**AMENDED SITE PLAN
HENNEP CULTIVATION &
PRODUCTION FACILITY**

located at
**160 Grove Street
Franklin, MA**

Date: December 19, 2022 Job No.: 4831
To: Mr. Greg Rondeau, Chairman
Cc:
From: Matt Crowley – BETA, Amy Love – Town Planner
Subject: **160 Grove Street Amended Site Plan**

DATE: December 29, 2022
TO: Franklin Planning Board
FROM: Department of Planning and Community Development
RE: 160 Grove Street
Field Change

Site Index Plan

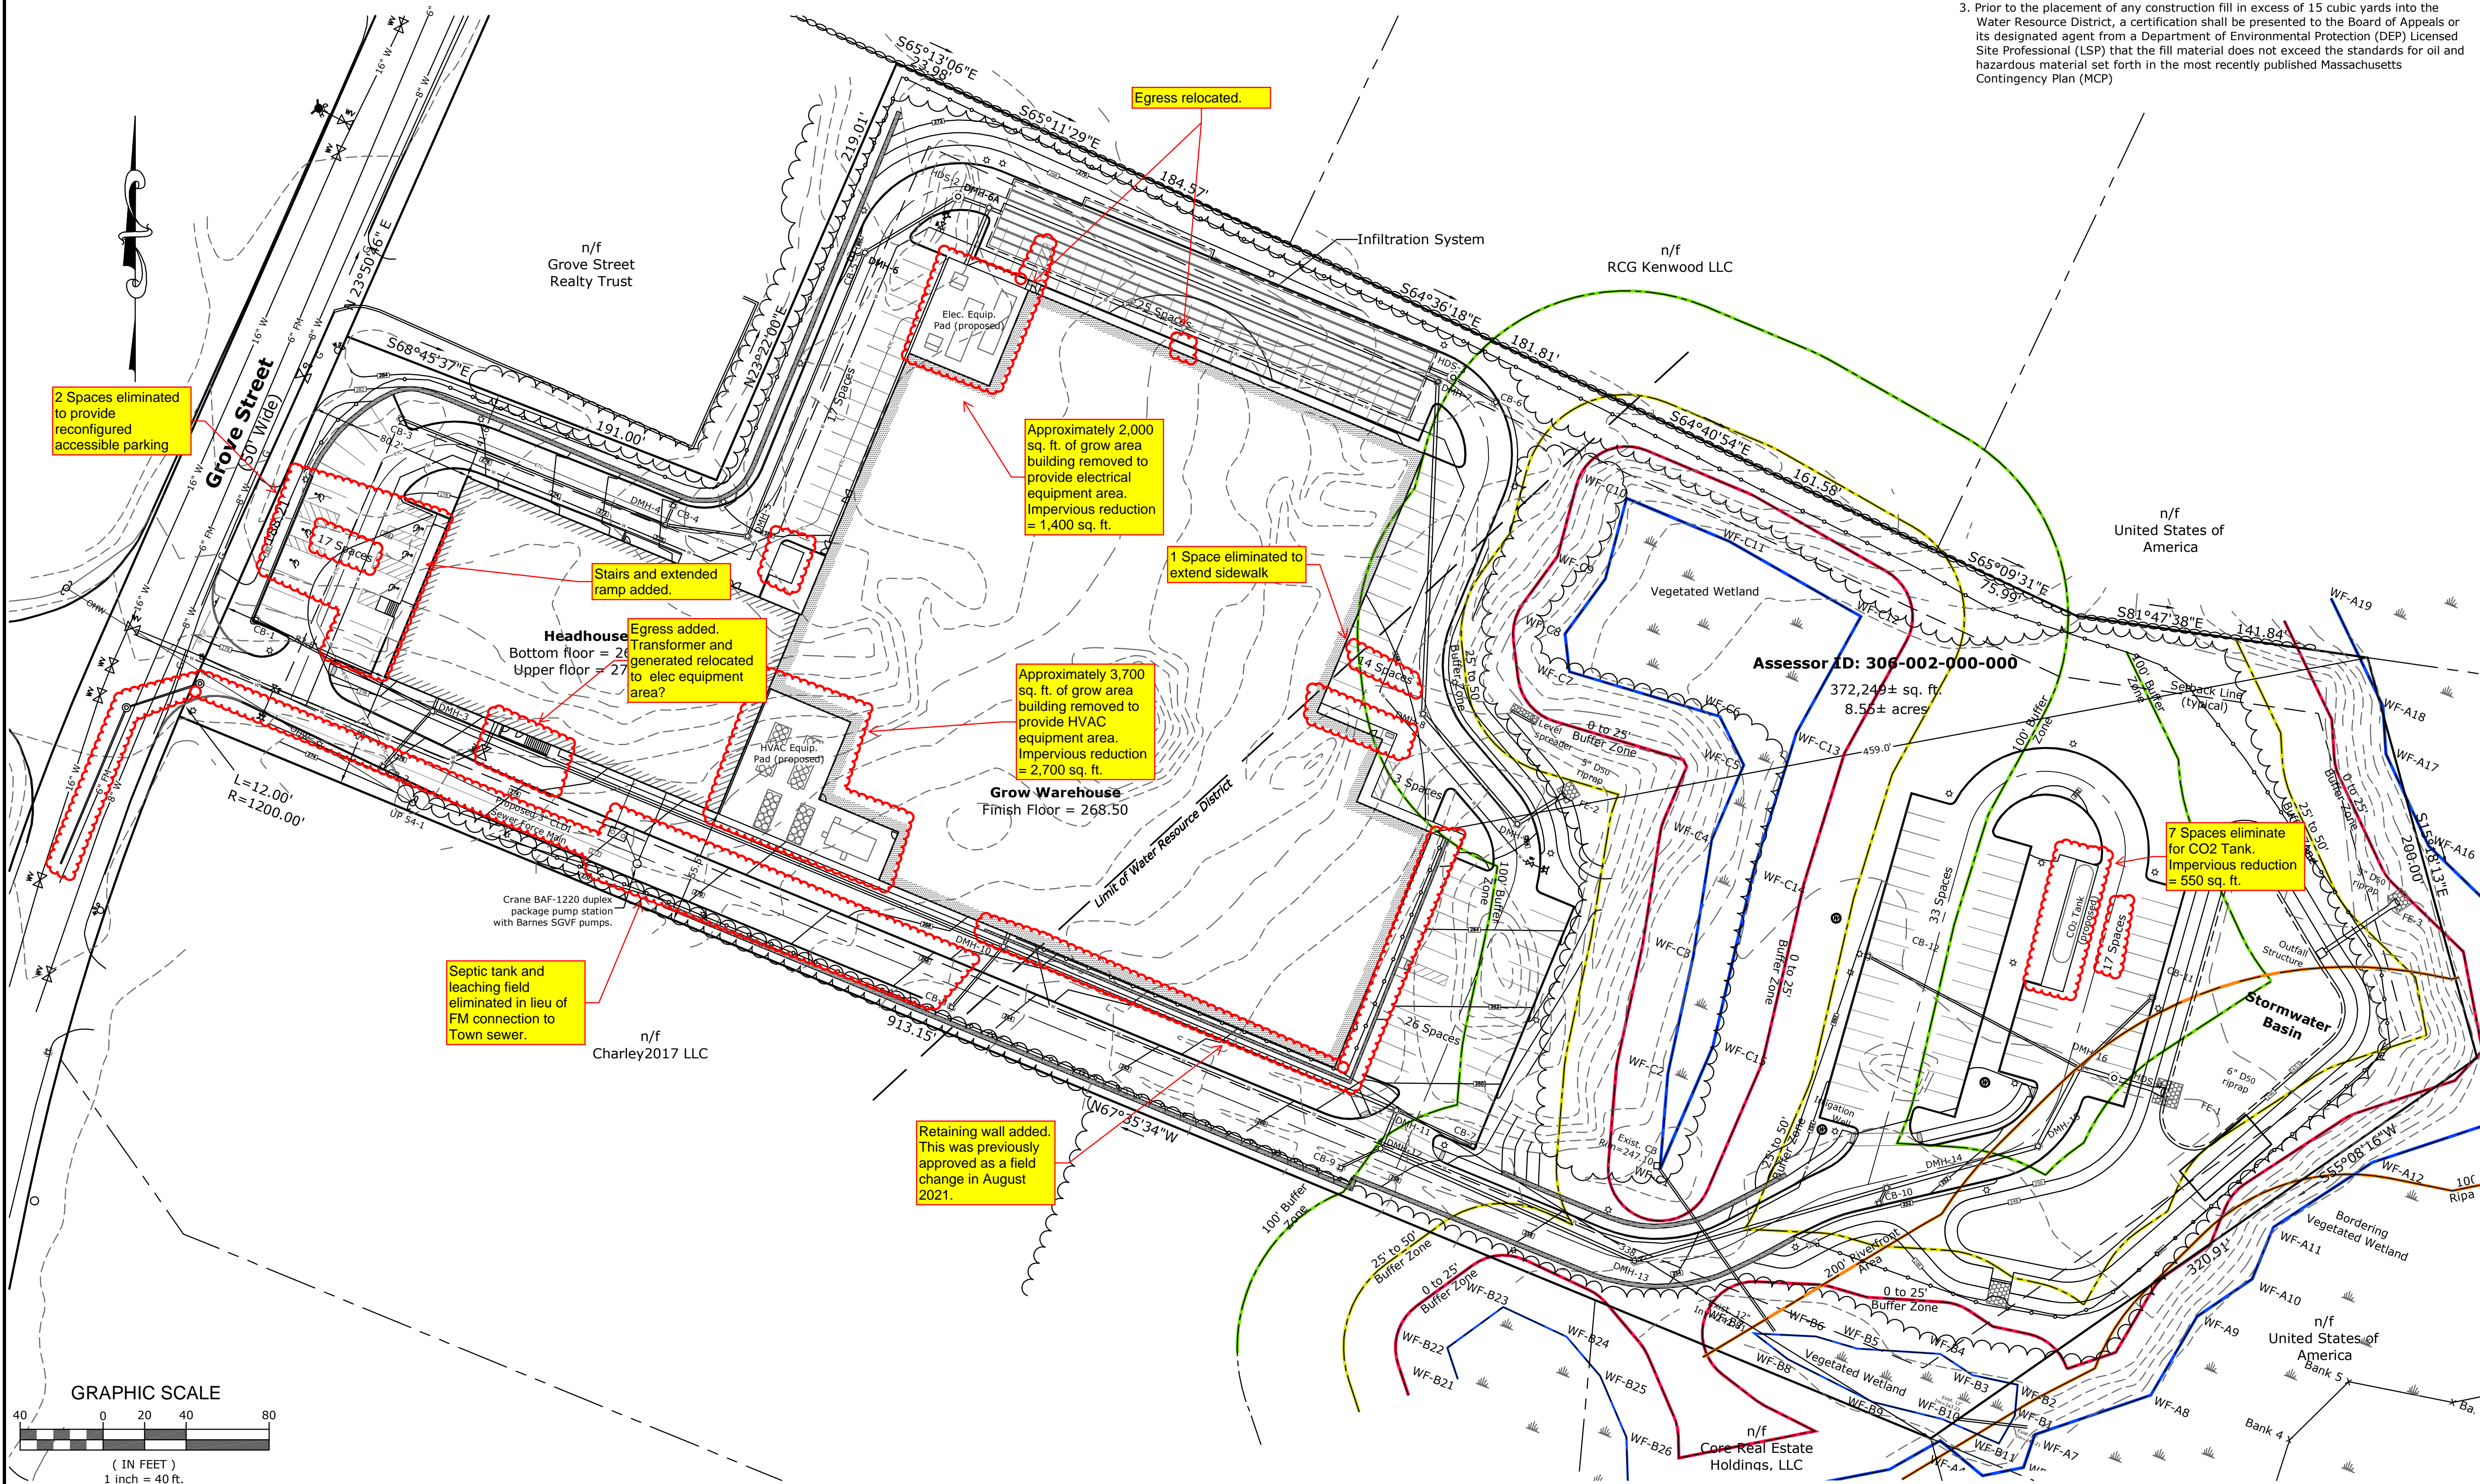
5. Bollards should be provided to protect the proposed CO2 tank and equipment pads from vehicles.
6. The Zoning Summary Table should be revised to indicate that the building height is now proposed to be two stories.
7. Revised Architectural Elevations should be provided for the Board's consideration.

Utility & Grading Plan

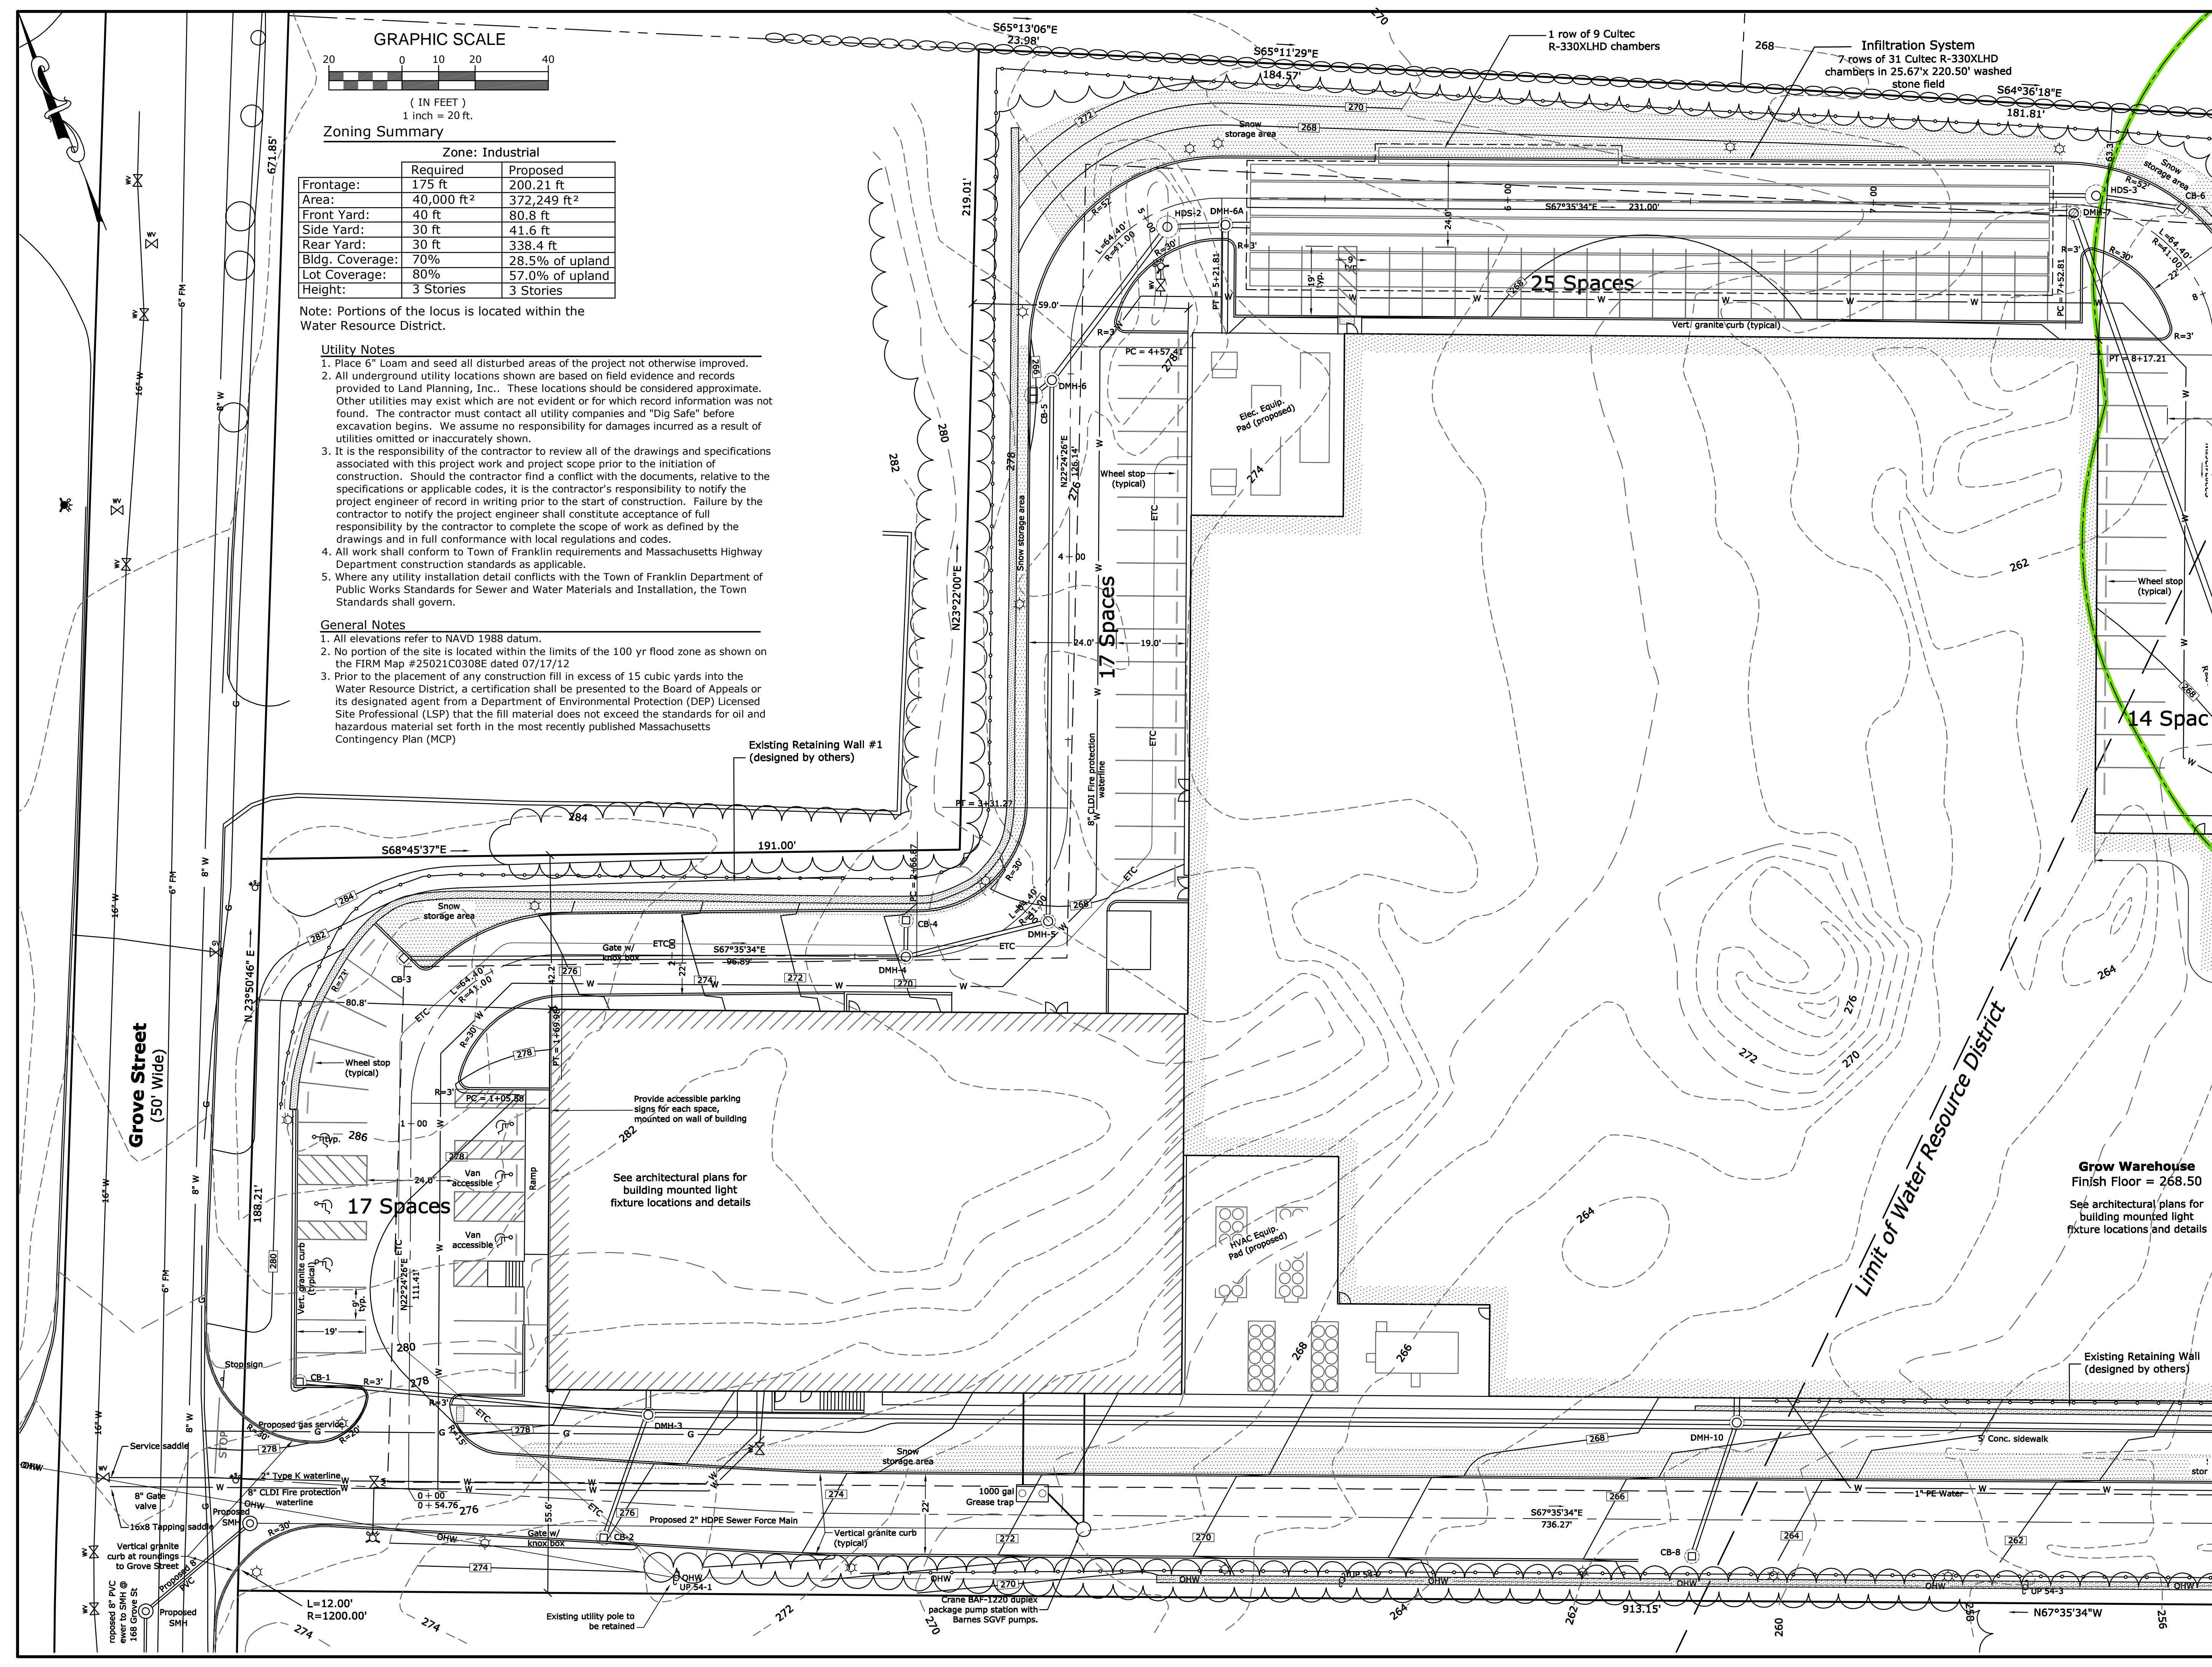
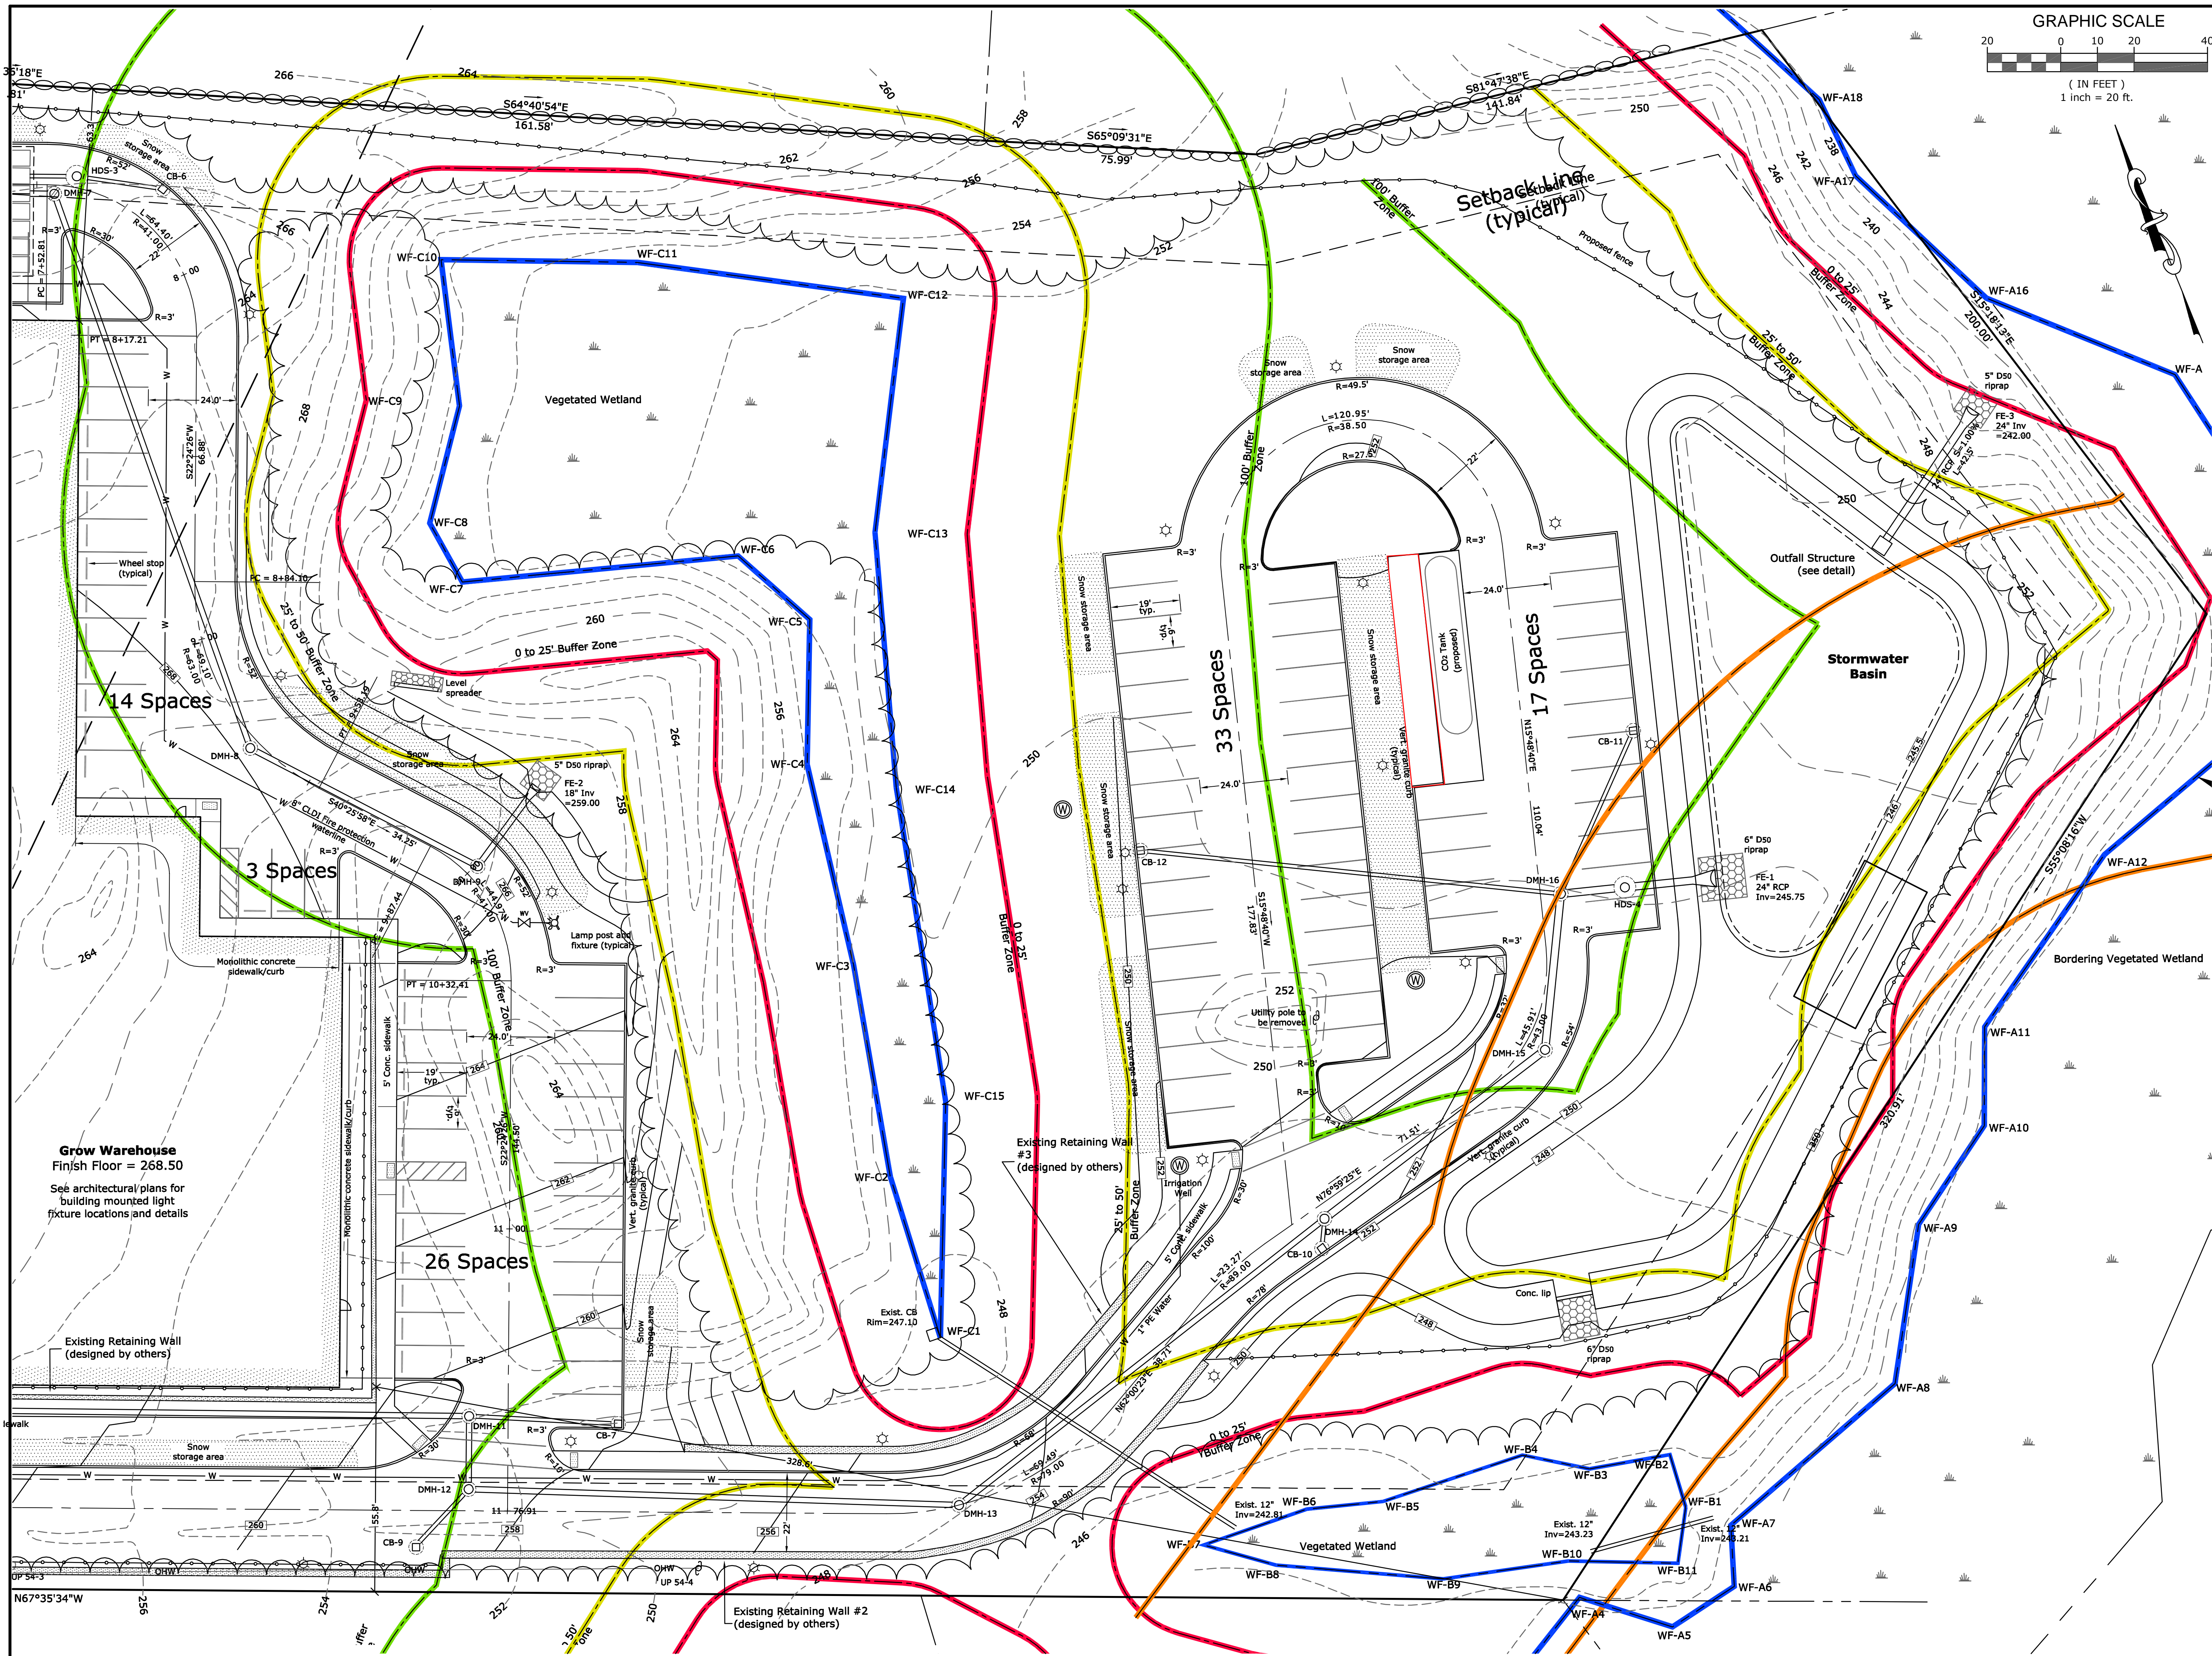
- The greenhouse footprint has been reduced (See Timothy Good's summary of architectural changes.)
- A retaining wall was added at the southeast corner of the greenhouse/inside corner of the intersection of driveways. During the approval process, it was assumed that the building foundation would serve as the retaining wall. The retaining wall allowed the site work to be completed while the building is constructed in phases.

- A stair and ramp have been added to the building's main entrance to accommodate additional height between the building's floors beyond what was assumed during the approval process. The accessible parking was reconfigured to provide the shortest distance between the parking and the ramp.

- The rear parking lot was reduced by 7 spaces to provide a pad for a proposed CO2 tank. The proposed tank and pad are located outside the 100-foot buffer zone.
